Release Notes

Firmware Update R&S[®] ESIB 4.34.2

for R&S[®] ESIB7, R&S[®] ESIB26, R&S[®] ESIB40

CISPR RMS-Detektor

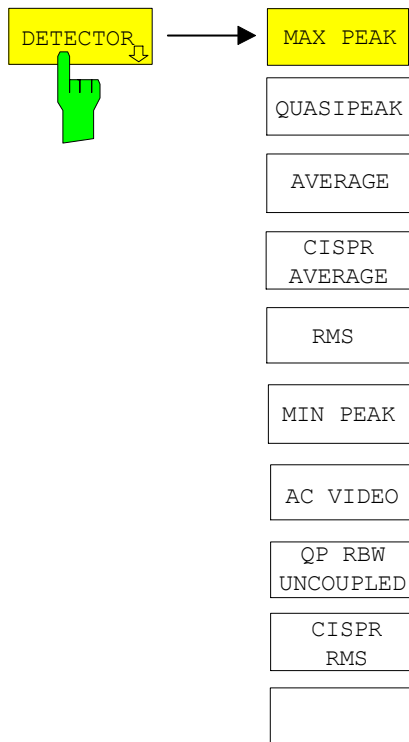
The weighting modes that can be selected have been extended by the detector CISPR RMS.

TRACE menu

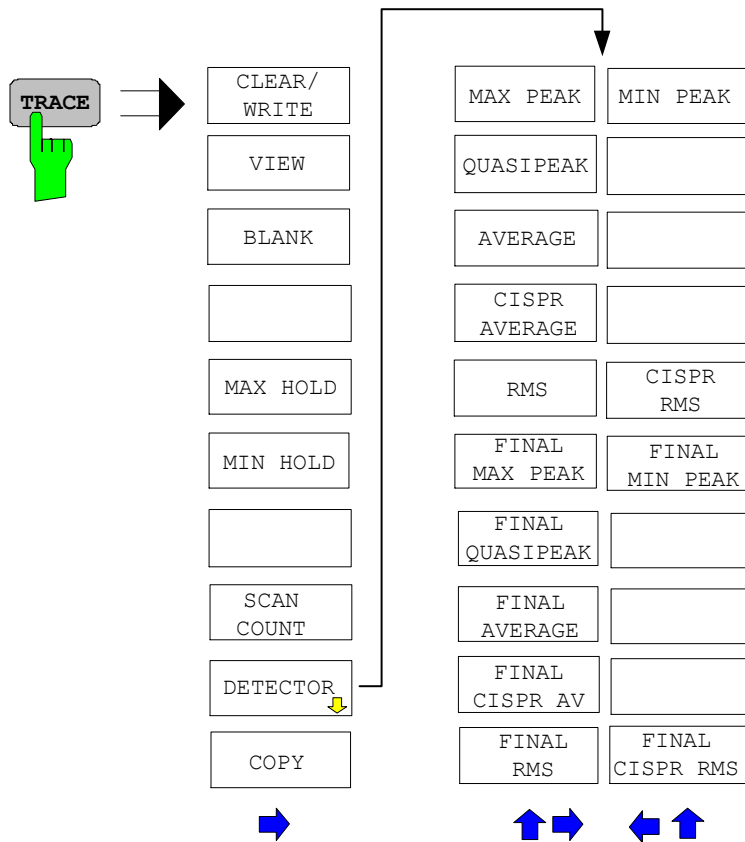
The *CISPR RMS* softkey activates the weighting detector according to a proposed amendment of CISPR 16-1-1 (CISPR/A/628/CD). The CISPR RMS average detector supplies a weighted reading of the input signal. When measuring the RMS-average according to the proposed amendment of CISPR 16-1-1, the maximum value of the RMS-average during the measurement time is displayed. The detector is used, for example, to measure pulsed sinusoidal signals with a low pulse repetition frequency. It is calibrated with the RMS value of an unmodulated sinusoidal signal. Averaging is with lowpass filters of the 2nd order (simulation of a mechanical instrument).

The *FINAL CISPR RMS* softkey selects the weighting rms detector according to CISPR 16-1-1 for the final measurement.
